NOTICE OF ADMINISTRATIVE DECISION

DR00-122-A [PAL15-49]

Rodeo Park CSP Amendment (Mobil/Q-Mart)

Minor Administrative Design Review

SITE MAP

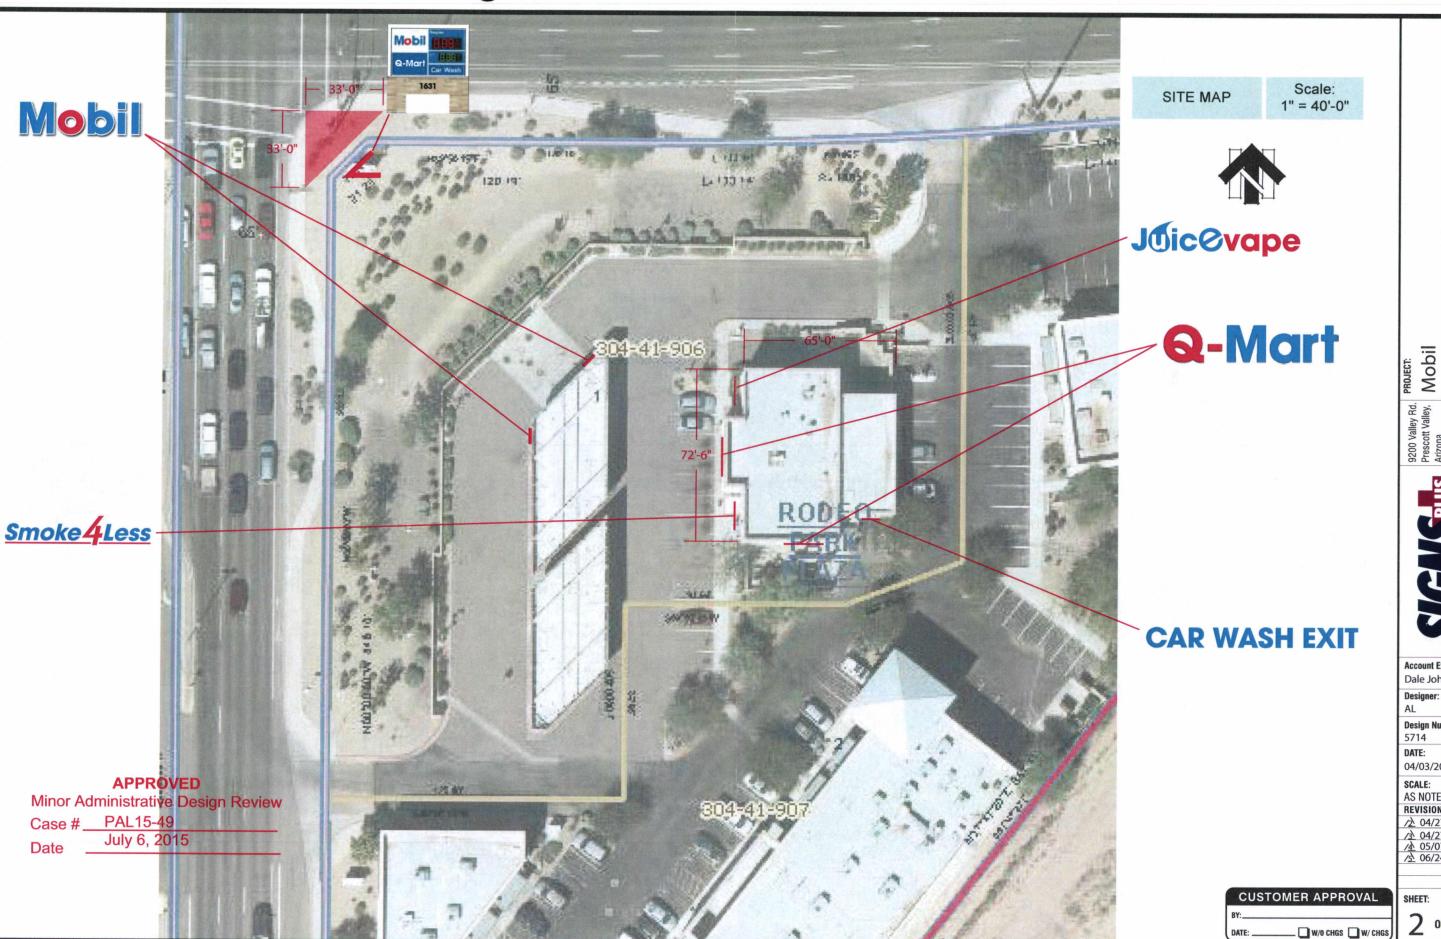
- d. TOTAL SF: 37.8 SF
 - e. Analysis MEETS APPLICABLE CRITERIA
- 4. Monument Sign, illuminated
 - a. Monument overall dimension is 12'x11'
 - b. Signage dimension is 6'6½"x 10'-½"

- c. TOTAL SF: 47.81sf

- d. The proposed angle of the monument sign faces is 45 degrees [LDC Glossary: All sides of a sign visible from any 1 location shall be measured in determining the area of the sign, except that only 1 side of a sign shall be measured* if the 2 sides are back-to-back or separated by an interior angle of 45 degrees or less].

- e. 4.407.C.2.a(2) Height Criteria. Signs shall be no greater than 12 feet in height to the top of design embellishments. The sign face shall be located between 2 feet and 10 feet above grade with design embellishments added to the top, sides or bottom of the sign; proposed sign face is at 10' AGL.

- f. 4.407.C.2.a(3) Area. The Monument Sign area shall not exceed 60 square feet; proposed sign face is 47.81sf.
- g. 4.407.C.2.a(4) Setback. Signs shall be set back a minimum of 3 feet from the right-of-way; the sign is set back 3 feet.

BUILDING SIGNAGE

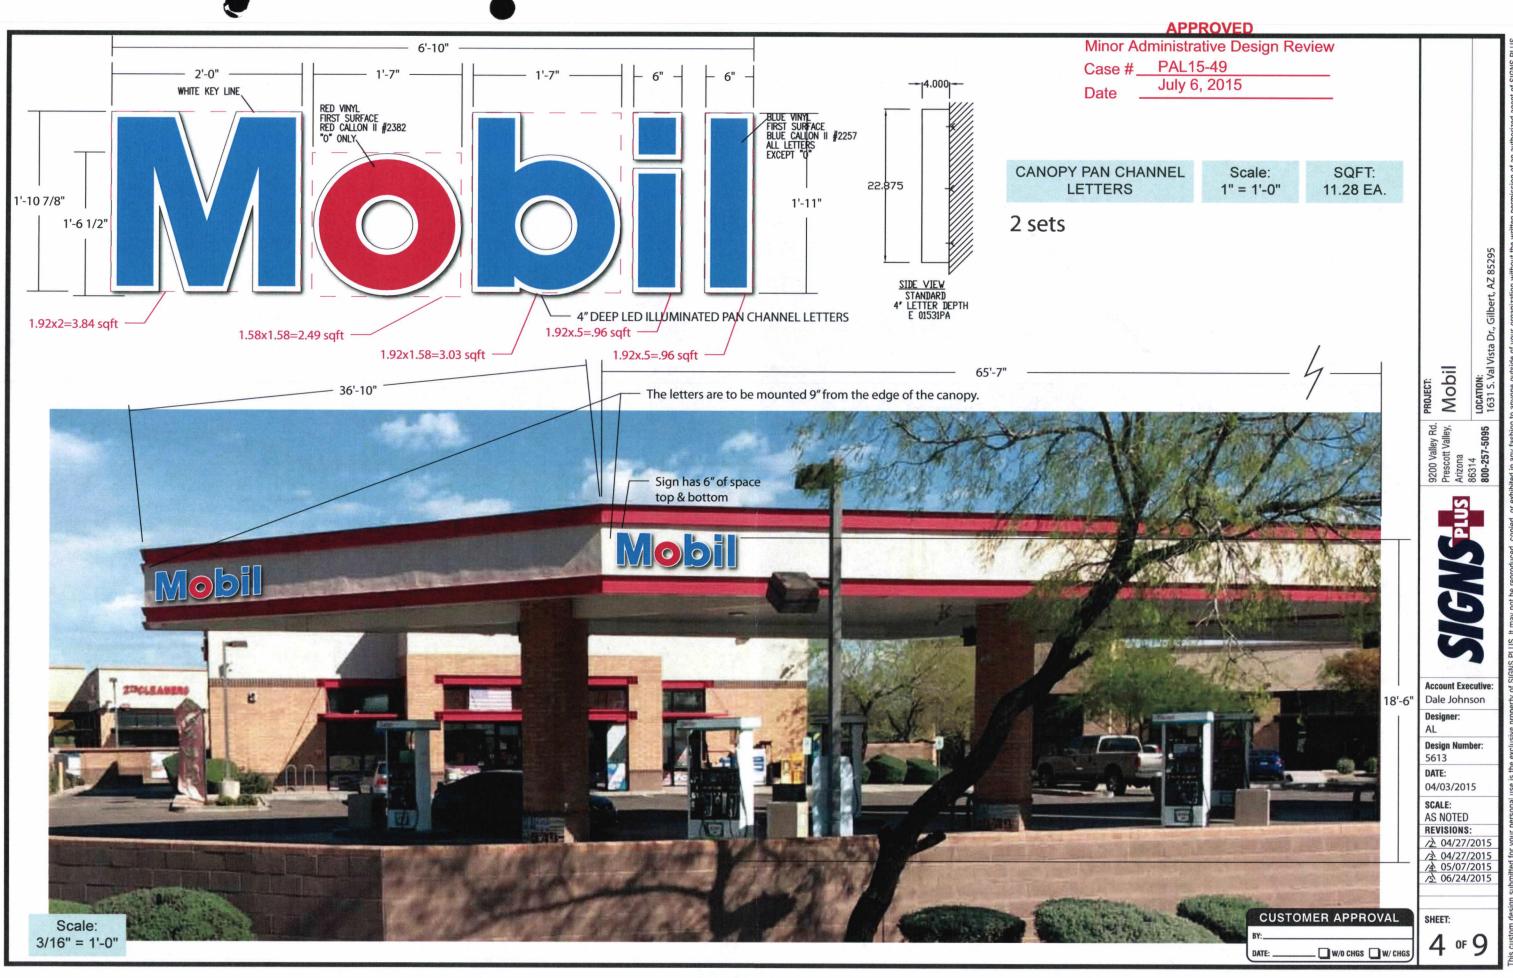
- e. Analysis MEETS APPLICABLE CRITERIA
- 3. 2x "Q-Mart" illuminated wall signs
 - a. 1x west elev; 2x south elev
 - b. 2' x 9'-5.5" each
 - c. Single SF: 18.9sf

CAR WASH EXIT

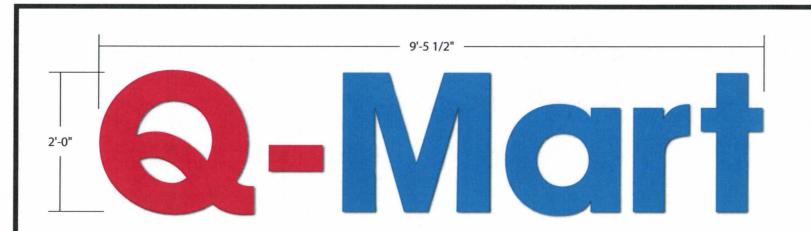
- 6. "JuiceEvape" non-illuminated wall sign
 - a. North elevation, 1x 2'-7" x12'-31/2"
 - b. TOTAL SF: 31.75 SF
 - c. Analysis MEETS APPLICABLE CRITERIA
- 7. "Car wash exit" illuminated wall sign:

- a. 11.5"x10.5"
 - b. TOTAL SF: 1.8 SF
 - c. Analysis MEETS APPLICABLE CRITERIA
